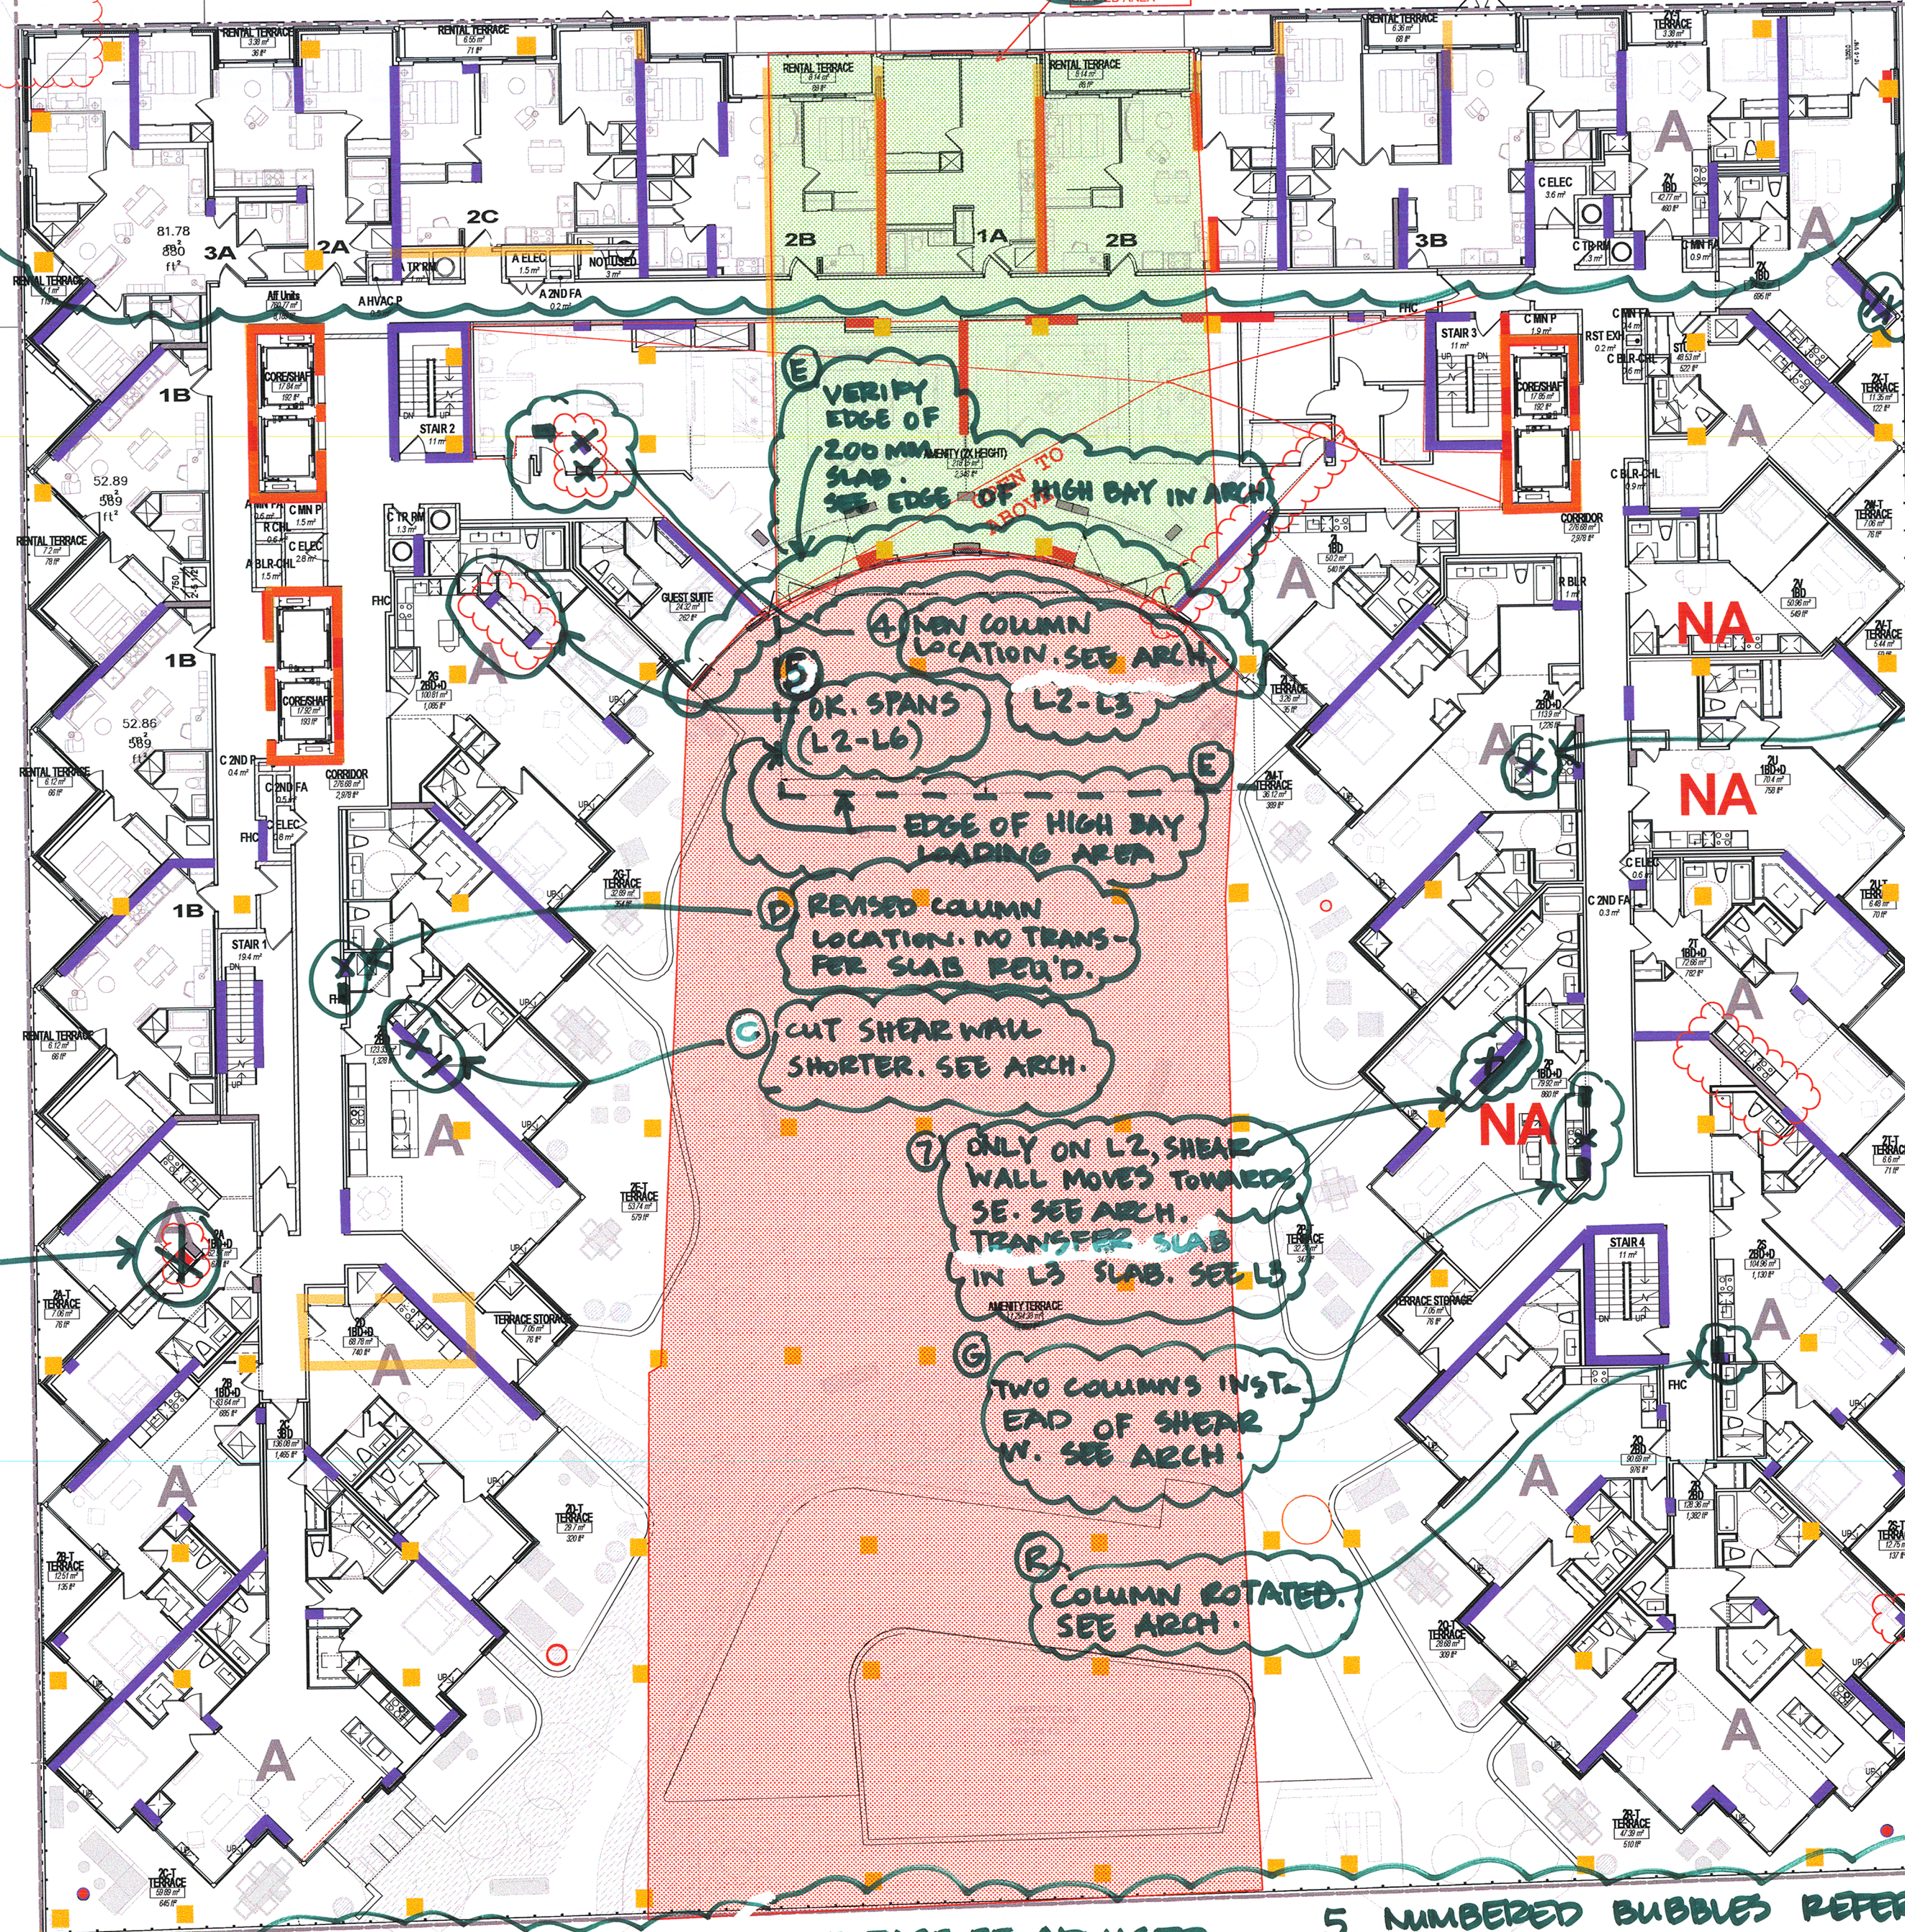
13 REVIEW ARCH. TYPICAL ALL FLOORS

3 CUT BACK SHEAR WALL. SEE ARCH.

- (X) QUESTION REFERENCE NO.
- PLEASE BE ADVISED BACKGROUND IS OUTDATED. SEE ARCH. FOR NEW BACKGROUND.
 - SOUTH EXIT STAIR STRUCTURAL TRANSFERS ON EAST & WEST WING TO BE COORDINATED.
 - STRUCTURE ON NORTH SIDE OF BLDG TO BE REVIEWED BY STEPHENSON. ARCH IS REVISED.
 - 300 MM & 1000 MM SLABS TO BE REPLACED BY 200 MM & 800 MM RESPECTIVELY PER DESIGN MTGS.

A KEEP COLUMN AS IS (SEE ARCH.) TRANSFER SLAB NEEDED IN L7 SLAB.

E VERIFY EDGE OF 200 MM SLAB. SEE EDGE OF HIGH BAY IN ARCH.

4 NEW COLUMN LOCATION. SEE ARCH. L2-L3

5 OK SPANS (L2-L6)

D REVISED COLUMN LOCATION. NO TRANSFER SLAB REQ'D.

C CUT SHEAR WALL SHORTER. SEE ARCH.

7 ONLY ON L2, SHEAR WALL MOVES TOWARDS SE. SEE ARCH. TRANSFER SLAB IN L3 SLAB. SEE L3

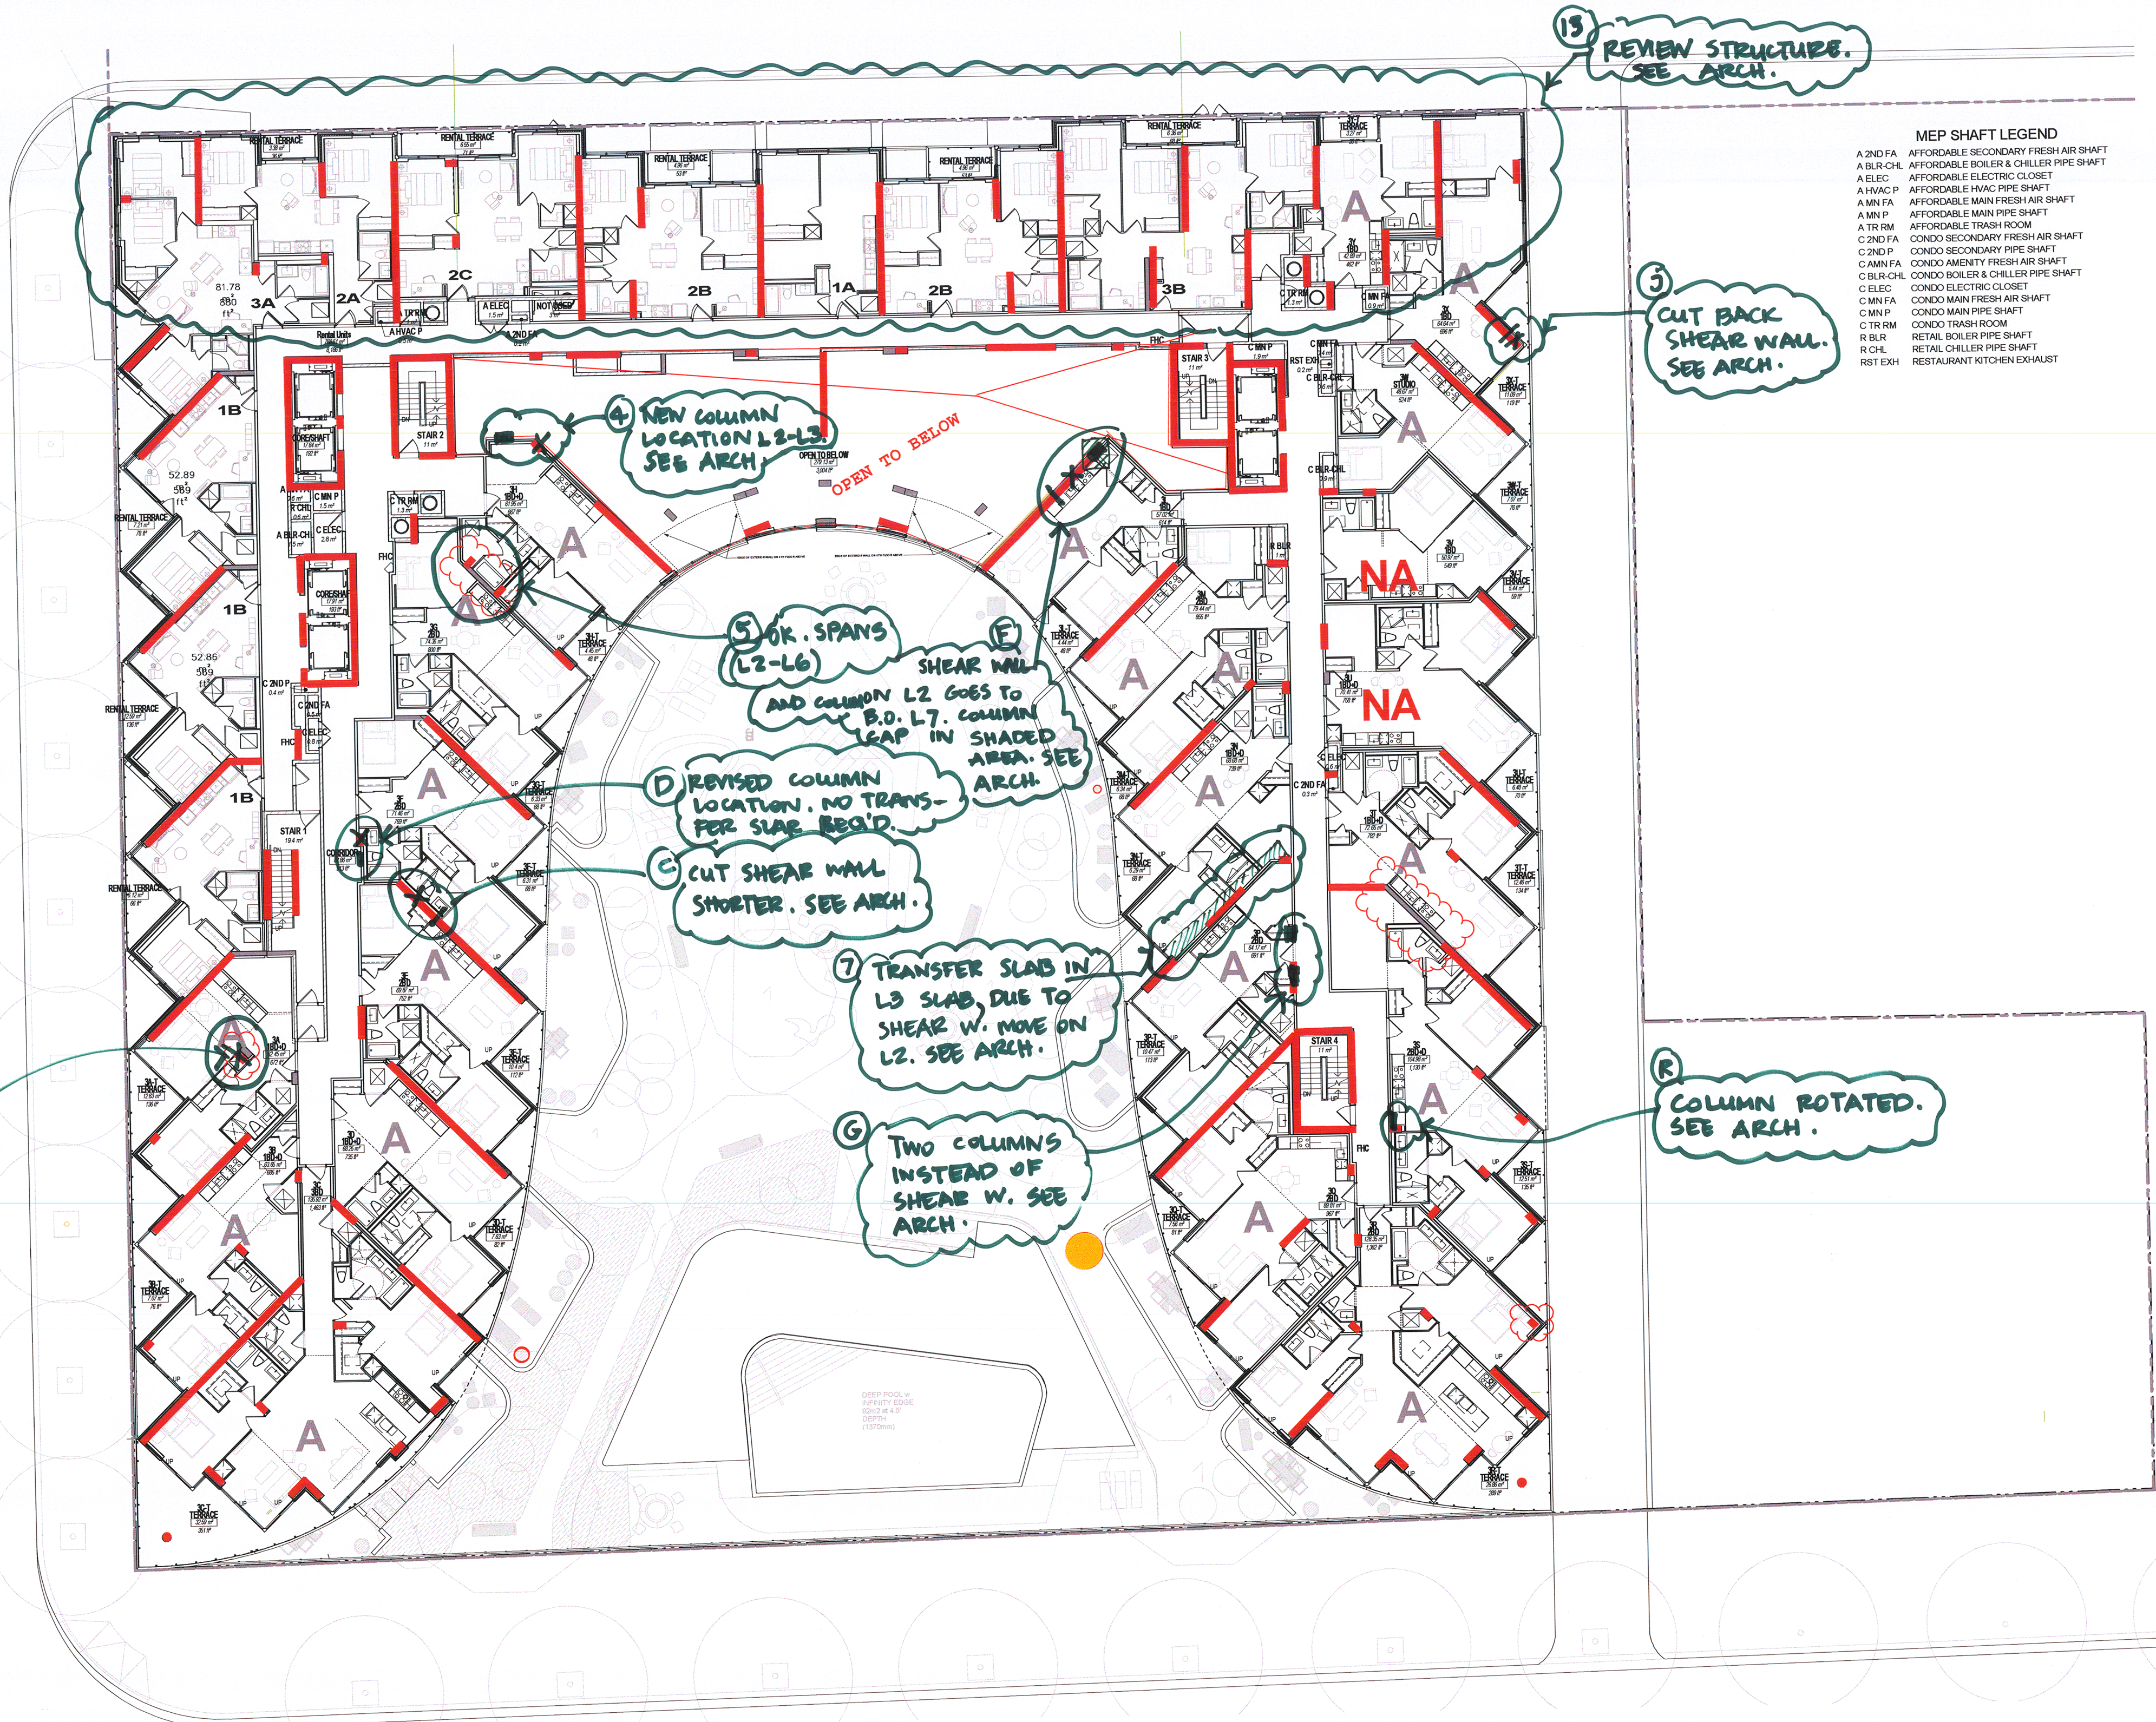
G TWO COLUMNS INST. EAD OF SHEAR W. SEE ARCH.

R COLUMN ROTATED. SEE ARCH.

7. ON A FEW LOCATIONS ON MECH. RMS, STR TO BE REMOVED IN. ARCH - PH-2 LEVEL.

6. PLEASE BE ADVISED, NOT ALL TRANSFER SLAB LOCATIONS ARE SHOWN. STR. ENG. TO NOTATE ALL.

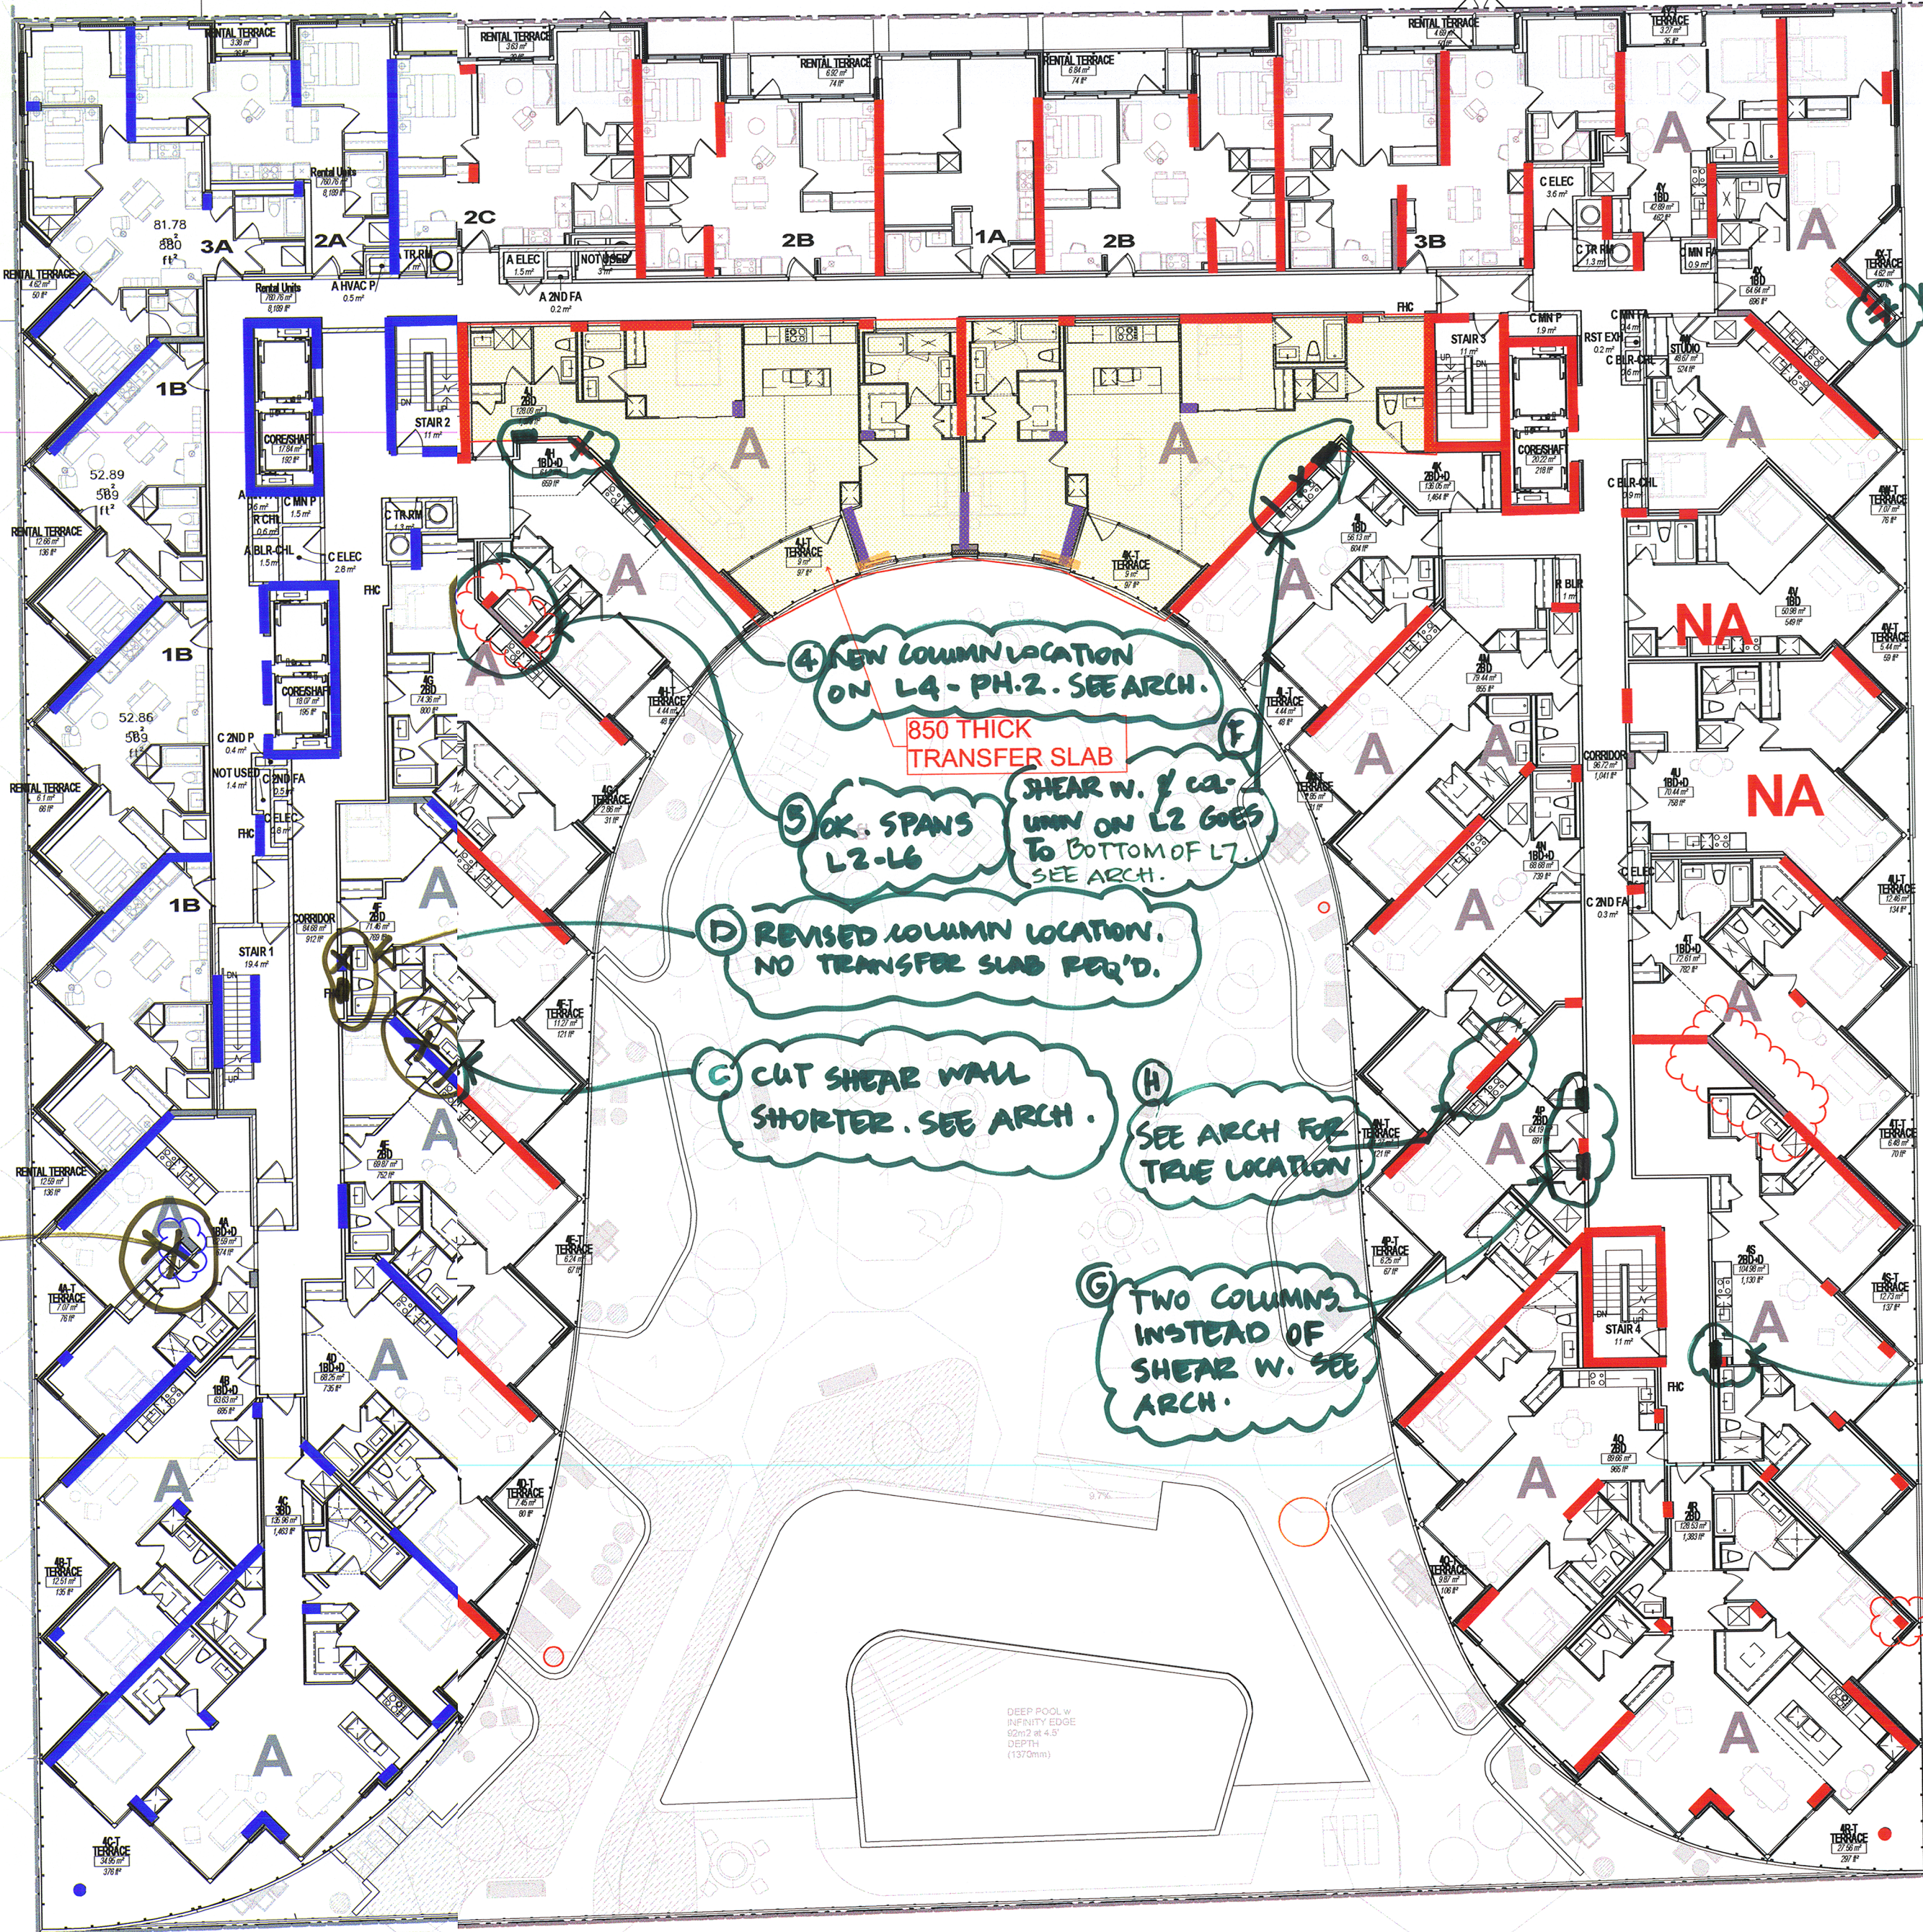
3 CUT BACK SHEAR WALL. SEE ARCH.

4 NEW COLUMN LOCATION ON L4 - PH.2. SEE ARCH.

5 OK SPANS L2-L6
SHEAR W. & COL-UMN ON L2 GOES TO BOTTOM OF L7. SEE ARCH.

6 REVISED COLUMN LOCATION. NO TRANSFER SLAB REQ'D.
